HOMEGATE STUDIOS AND SUITES

- 04/21/2023 MINOR AMENDMENT:
 ADD PERIMETER 6' FENCE - (3) VEHICLE TRAFFIC GATES - (5) PEDESTRIAN GATES FOR SECURITY ON PROPERTY NEEDED DUE TO INCREASED VOLUME OF THEFT AND VANDALISM.
 RE NUMBERED THIS SHEET
 (ADDED TAYLOR FENCE DRAWING SHEETS 4 THRU 8 FOR DETAILED INFORMATION)

R	RIES	04/21/23	EXTENDED STAY AMERICA PROPERTY AMENDMENT FENCE AND GATES SITE PLAN	
			TAYLOR FENCE AUTOMATION SECURITY 601 South Wahsatch Ave. Suite A Colorado Springs, CO 80903	
			SHEET 4 OF 8

HOMEGATE STUDIOS & SUITES INC.
Aurora, Colorado
LANDSCAPE PLAN

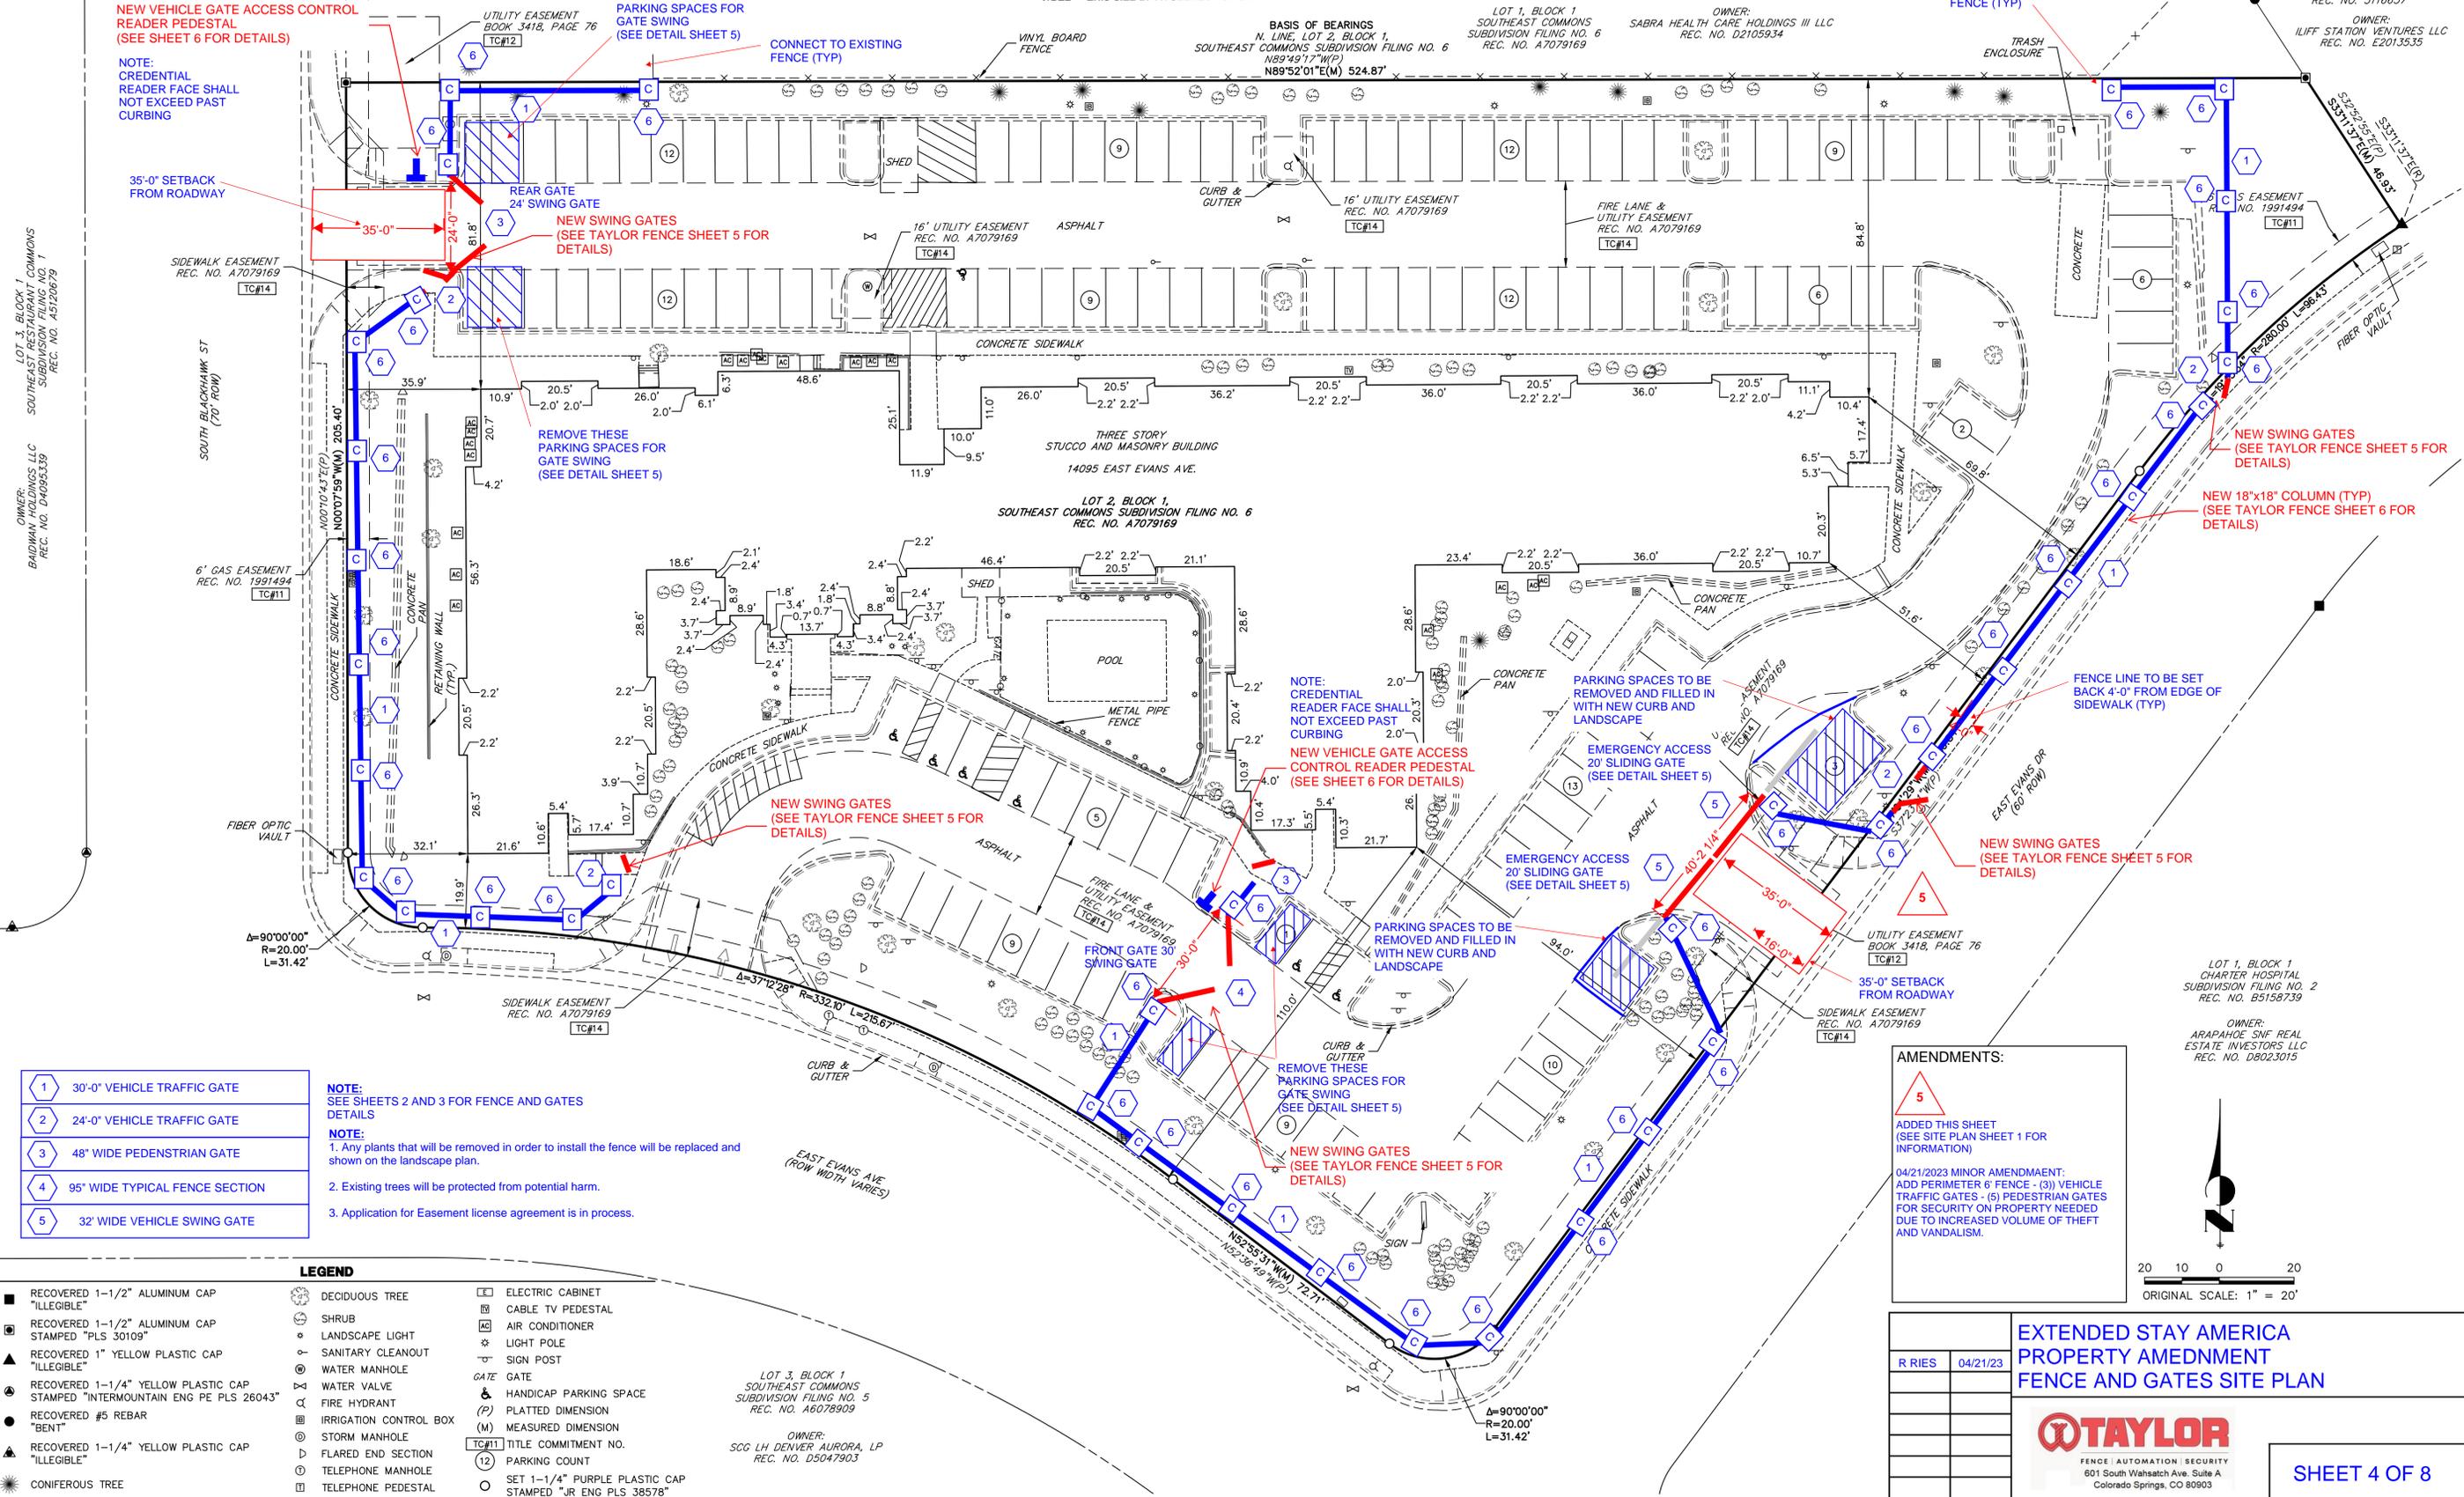
04/21/2023 MINOR AMENDMENT:
ADD PERIMETER 6' FENCE - (3) VEHICLE TRAFFIC GATES - (5) PEDESTRIAN GATES FOR SECURITY ON PROPERTY NEEDED DUE TO INCREASED VOLUME OF THEFT AND VANDALISM.
(ADDED TAYLOR FENCE DRAWING SHEETS 4 THRU 8 FOR DETAILED INFORMATION)

NEW FENCE AND GATE LINE (SEE TAYLOR FENCE DRAWING SHEET 4 FOR DETAILS)

1 **DETAIL 1**
TYPICAL 95" FENCE SECTION
N.T.S

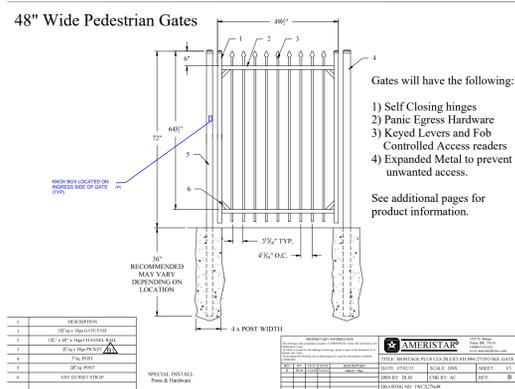
Montage powder coated Black Wrought Iron Fence. 6' High Press Point Fence. Fence will follow just inside property line and butt up to existing privacy fence at rear of property and up to setbacks to gates.

2 **DETAIL 2**
48" PEDESTRIAN SWING GATE
N.T.S

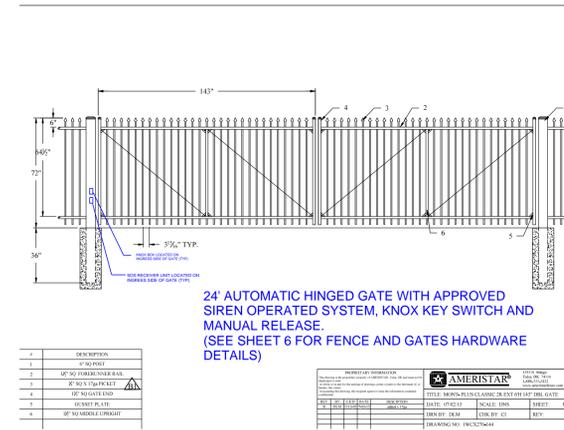
5 Pedestrian Gates matching fencing 48" Wide with Panic Bars and Onity Card Readers (Back Pedestrian Gate will be Exit Only)

3 **DETAIL 3**
REAR GATE
24'-0" VEHICLE TRAFFIC SWING GATE
N.T.S

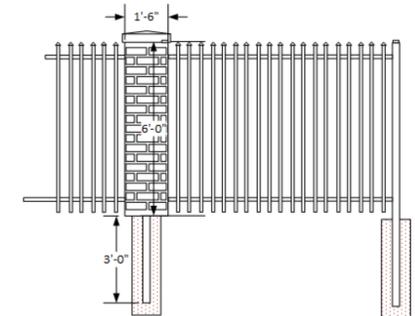
Montage powder coated Black Wrought Iron Double Swing Press Point Automatic Gate. 24' Wide x 6' High with 6" ground clearance and set back 35' Min. (FROM EDGE OF TRAVELWAY))

4 **DETAIL 4**
FRONT GATE
30'-0" VEHICLE TRAFFIC SWING GATE
N.T.S

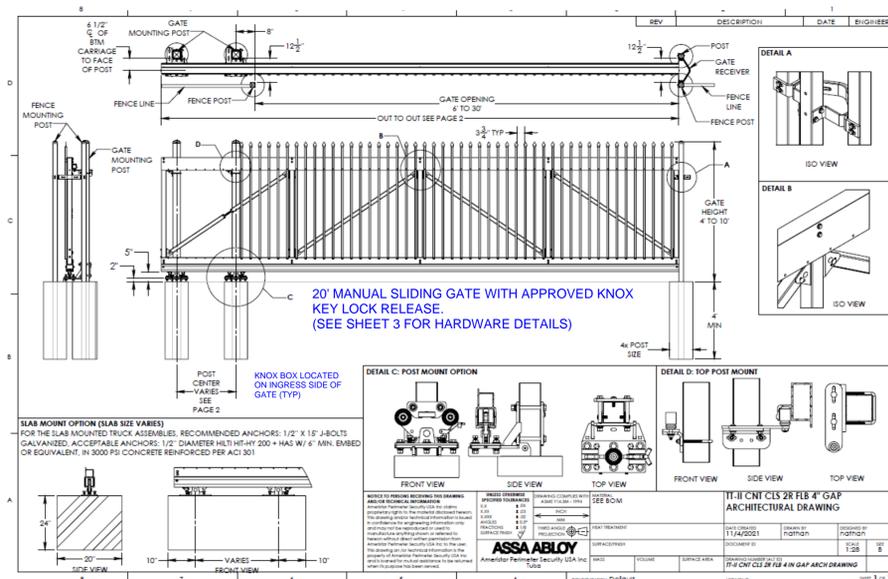
Montage powder coated Black Wrought Iron Double Swing Press Point Automatic Gate. 30' Wide x 6' High with 6" ground clearance and set back 35' Min.(FROM EDGE OF TRAVELWAY)
Powered by Lift Master CSL24UL Motor, OSO System, Knox Key Switch & Manual Release (Required by City of Aurora), Onity Card Reader Entry (Provided by ESA), Exit Sensor & Loop Detector Monitoring Photocell. Located Middle of parking lot (E Evans Ave Side of Bldg.) 100' approx. from front entrance so there are parking spaces for guest to check-in

1 FIRST FLOOR BUILDING PLAN (LEFT WING)- ELECTRICAL
 SCALE: 1/8" = 1'-0"

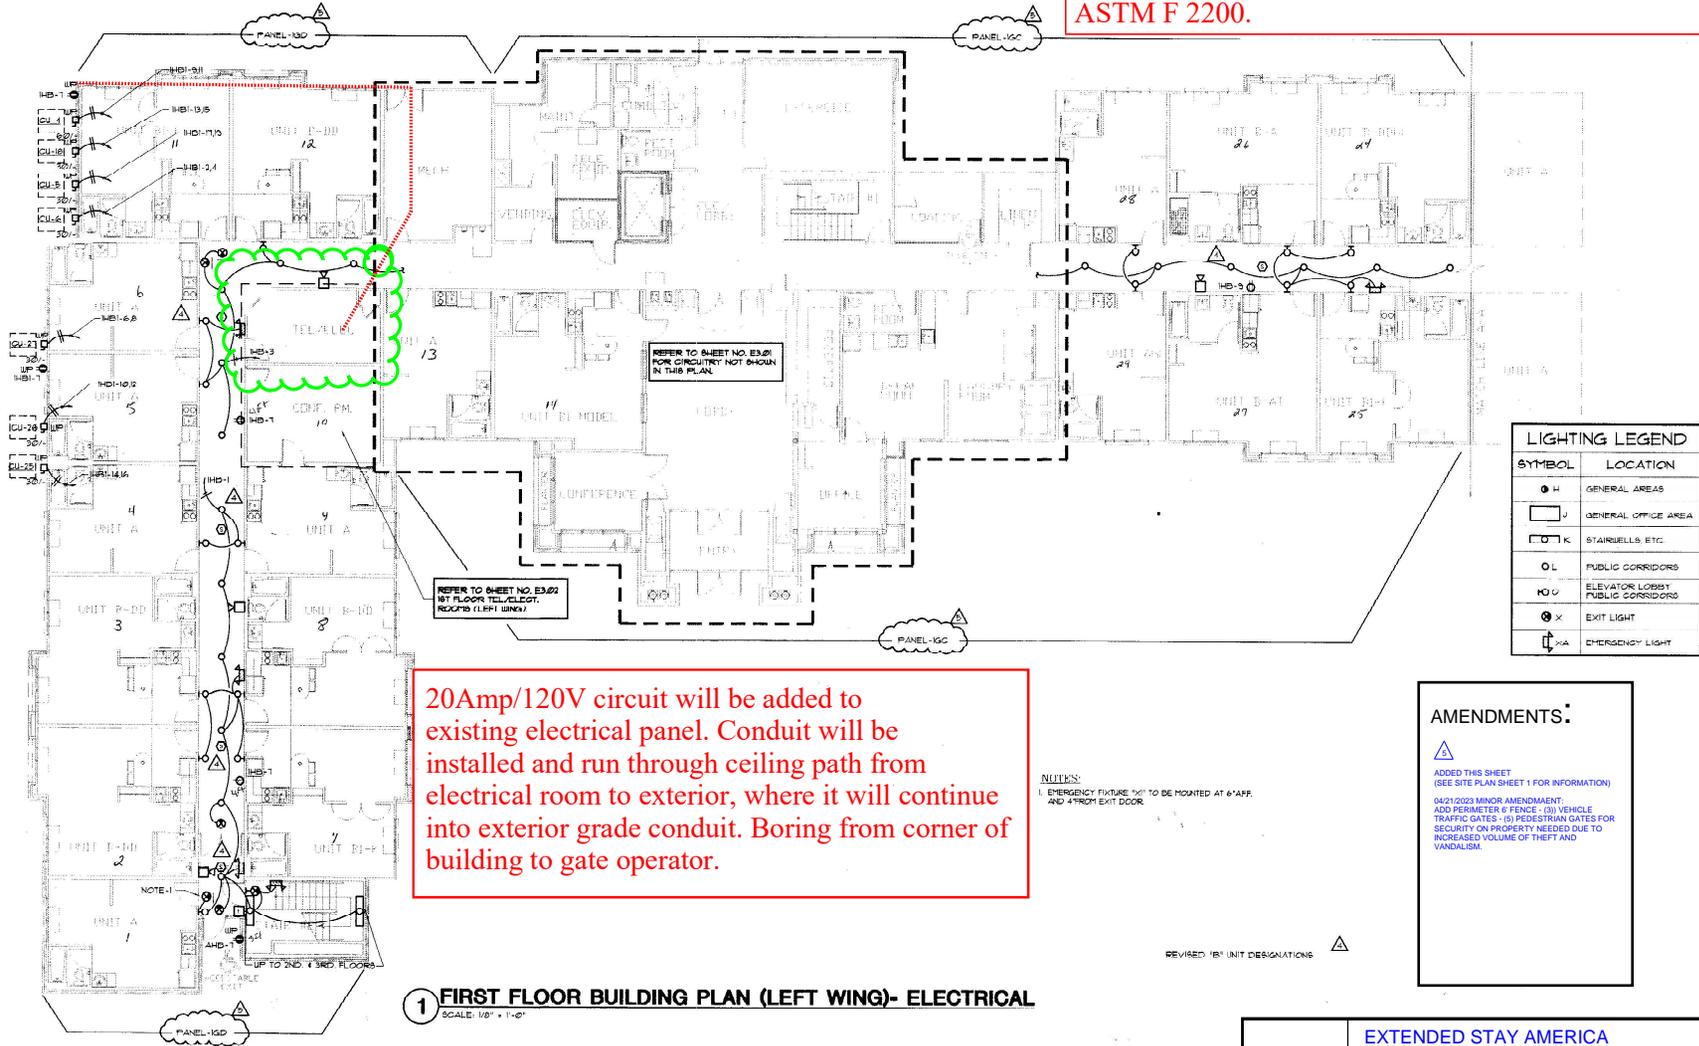
Electric gate operators, where provided, shall be listed in accordance with UL 325. Gates intended for automatic operation shall be designed, constructed and installed to comply with requirements of ASTM F 2200.

20Amp/120V circuit will be added to existing electrical panel. Conduit will be installed and run through ceiling path from electrical room to exterior, where it will continue into exterior grade conduit. Boring from corner of building to gate operator.

1 FIRST FLOOR BUILDING PLAN (RIGHT WING)- ELECTRICAL
 SCALE: 1/8" = 1'-0"

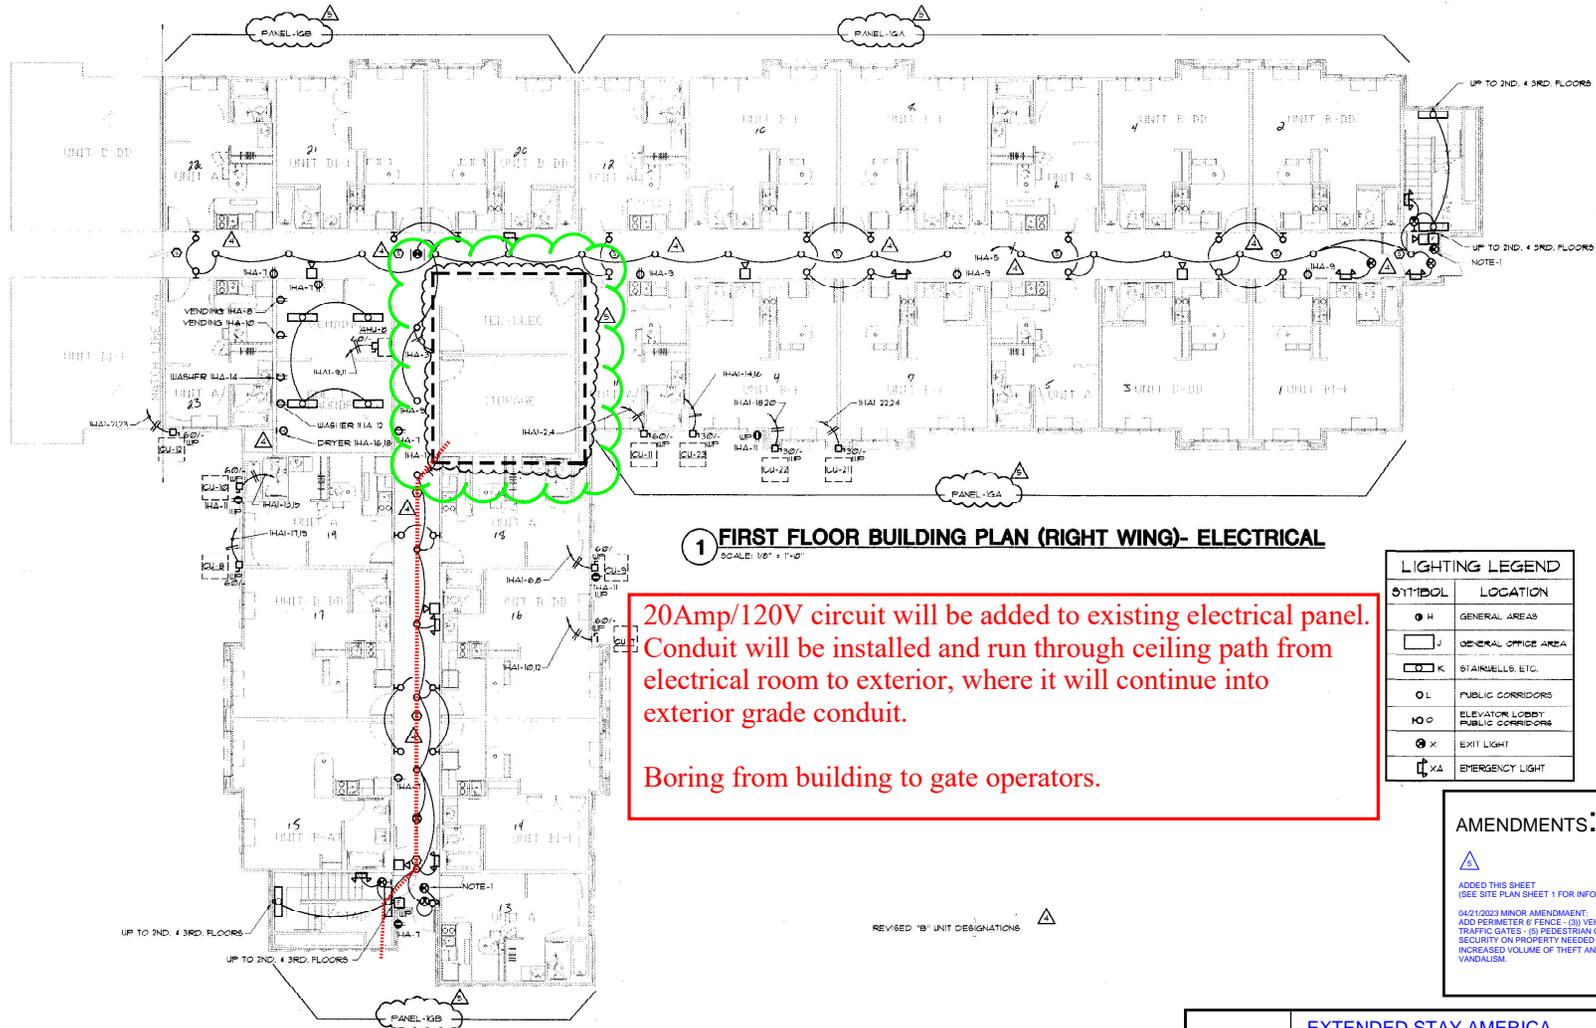
Electric gate operators, where provided, shall be listed in accordance with UL 325. Gates intended for automatic operation shall be designed, constructed and installed to comply with requirements of ASTM F 2200.

20Amp/120V circuit will be added to existing electrical panel. Conduit will be installed and run through ceiling path from electrical room to exterior, where it will continue into exterior grade conduit.
 Boring from building to gate operators.
